Revision Control Record

DOOR SWITCH

9087

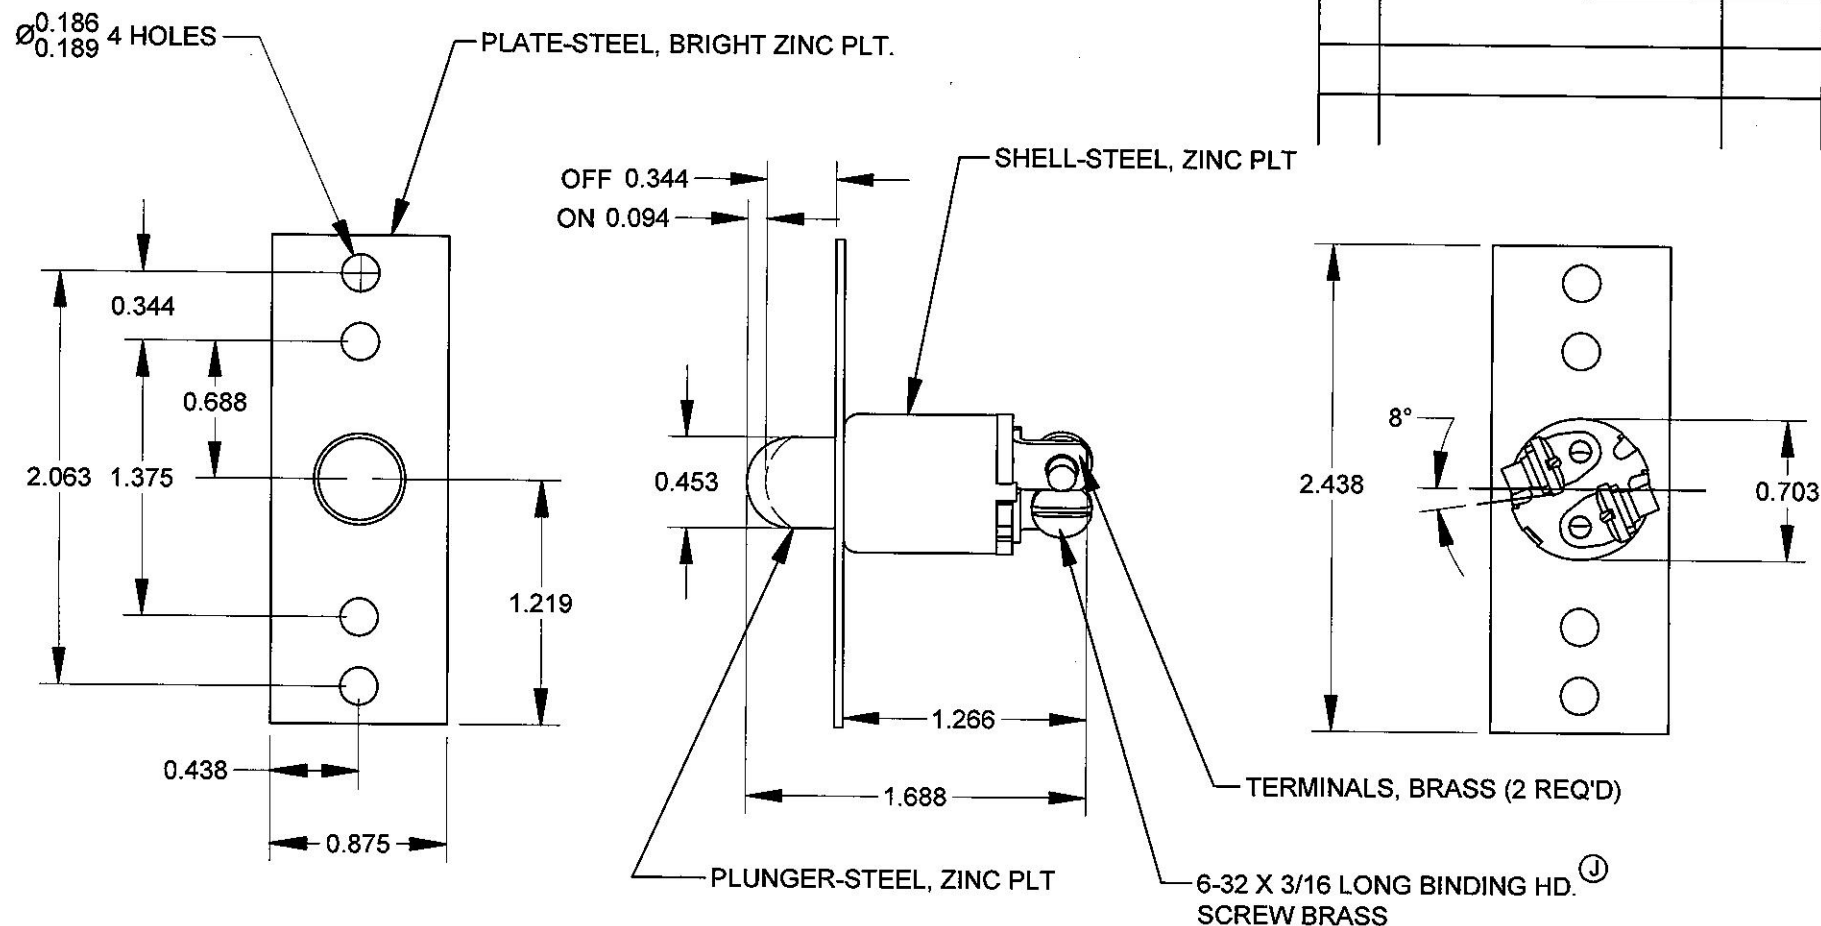
Rev.	Description of Change	ECN No.	Date
J	CHANGE NOTE	09170	03/03/09

^(J) NOTE:
1. ALL DIMENSIONS ARE REFERENCE ONLY
